HEGNPG

Places for People revised planning applications - your response

Community Zoom presentation
11th January 7-8.30pm

Advice from our Highways consultant

Places for People images for Terlings/Pye Corner road

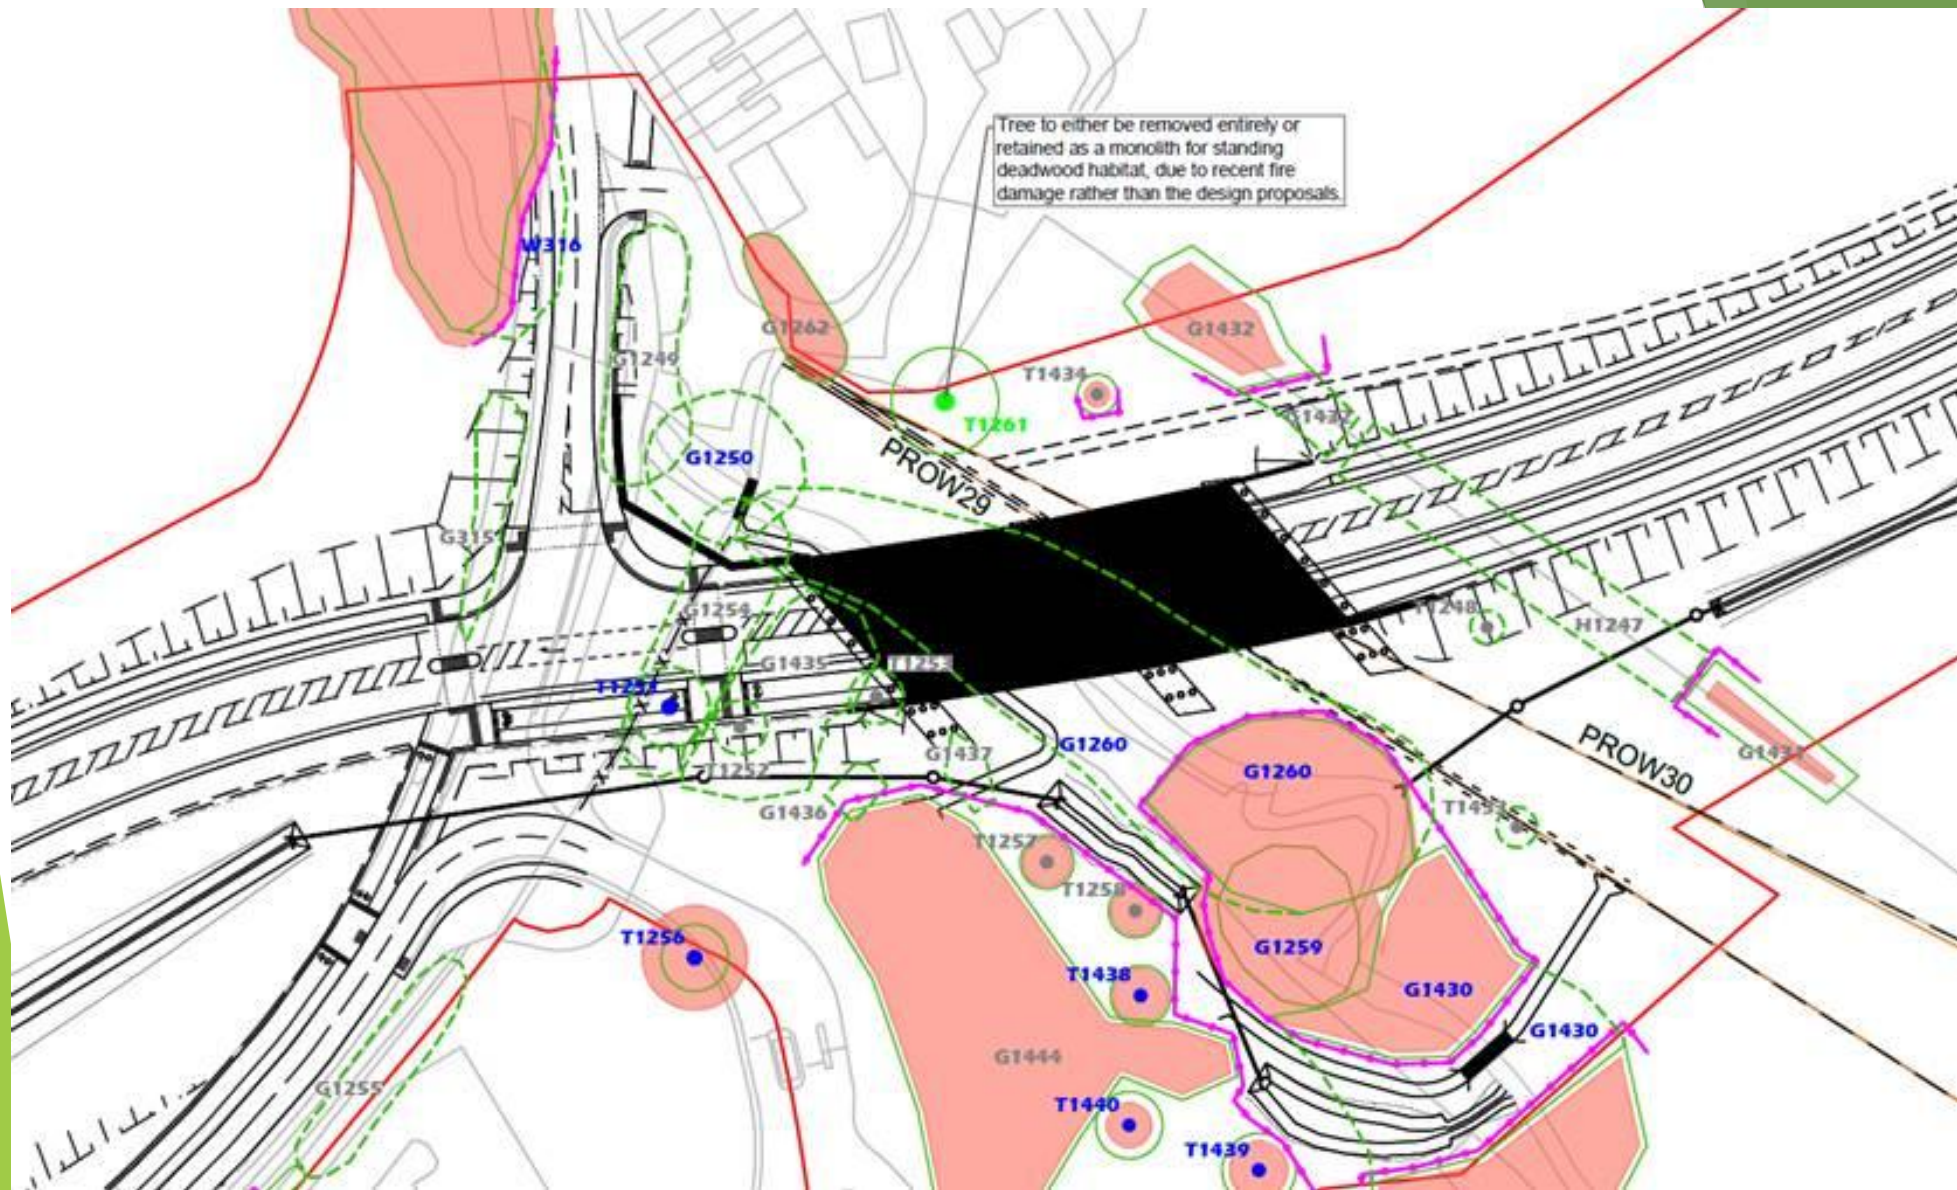
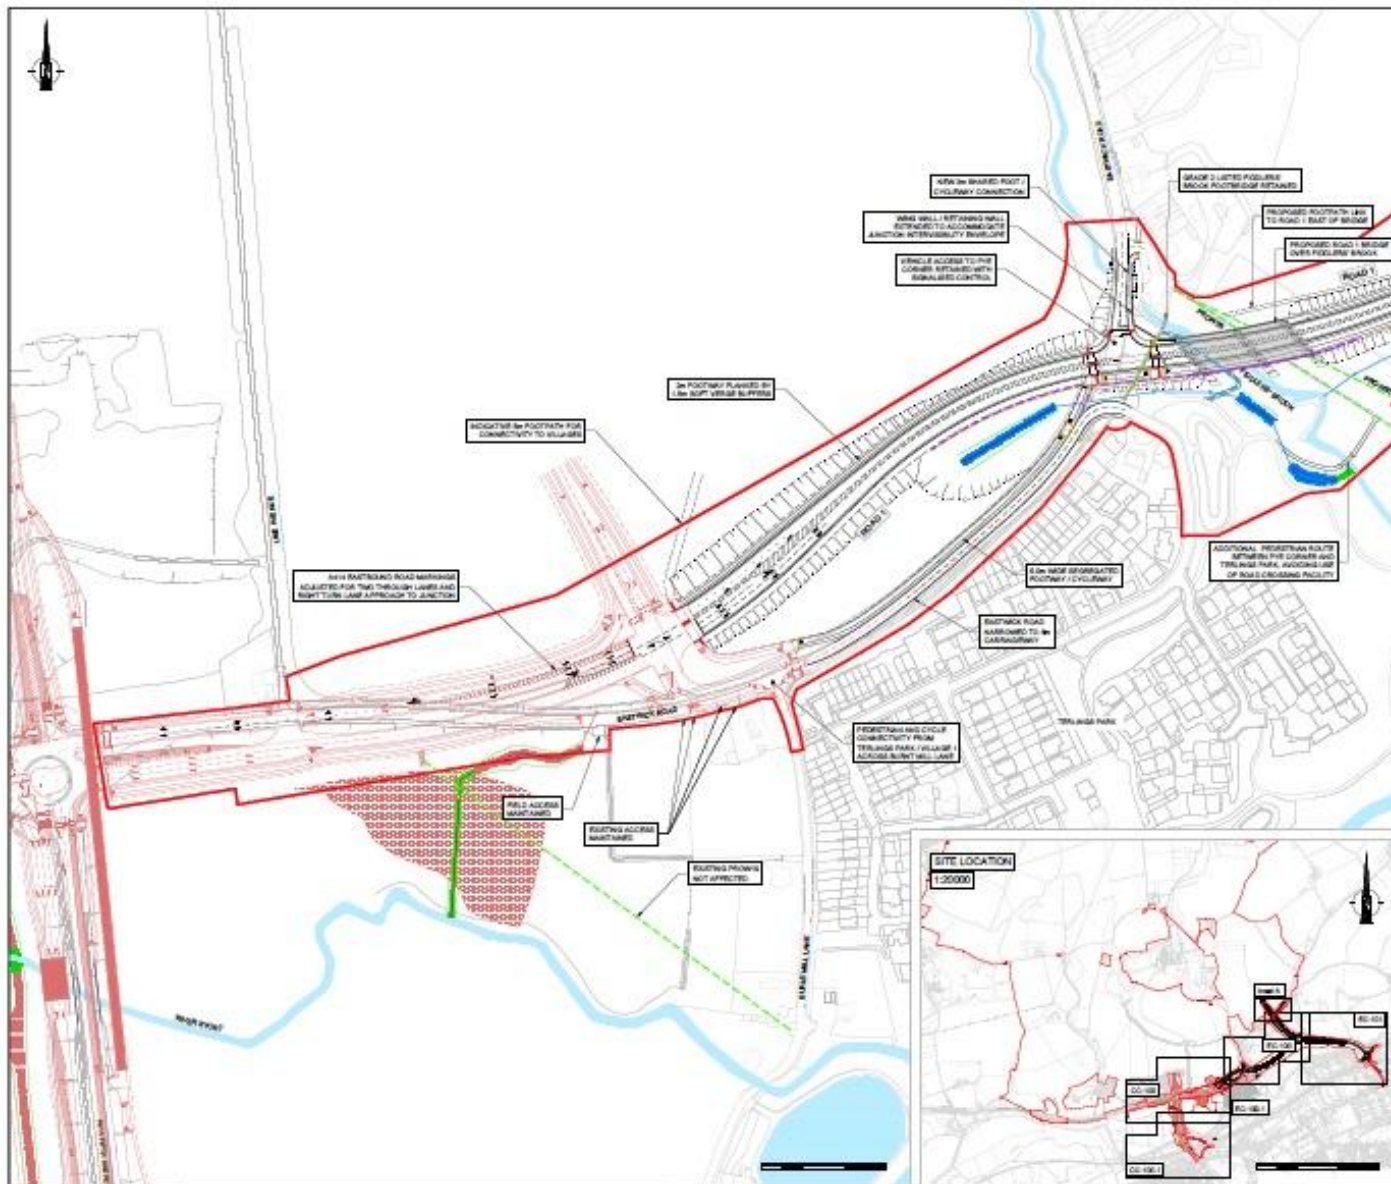
- They do not show any lorries using the road **but** they are proposing that the Eastwick bridge is designed to cater for the highest lorries allowed on the trunk roads. Showing us the impact of a passing transit van rather than a high lorry seems inappropriate, especially as the road links to an industrial area?

- They are proposing to cut down a mature (100 year old?) specimen oak tree, currently in Terlings ownership - how will they achieve 10% net biodiversity gain from felling so many trees

- Why they are wanting to include so much of Terlings land in their planning application boundary when it appears to be unchanged? If they want to use it as a construction site that has major adverse consequences.

- How they will provide replacement community space for residents to replace the space they seem to want to acquire through compulsory purchase powers?

- The effectiveness of the noise attention measures proposed
- The new 'gateway' into Terlings
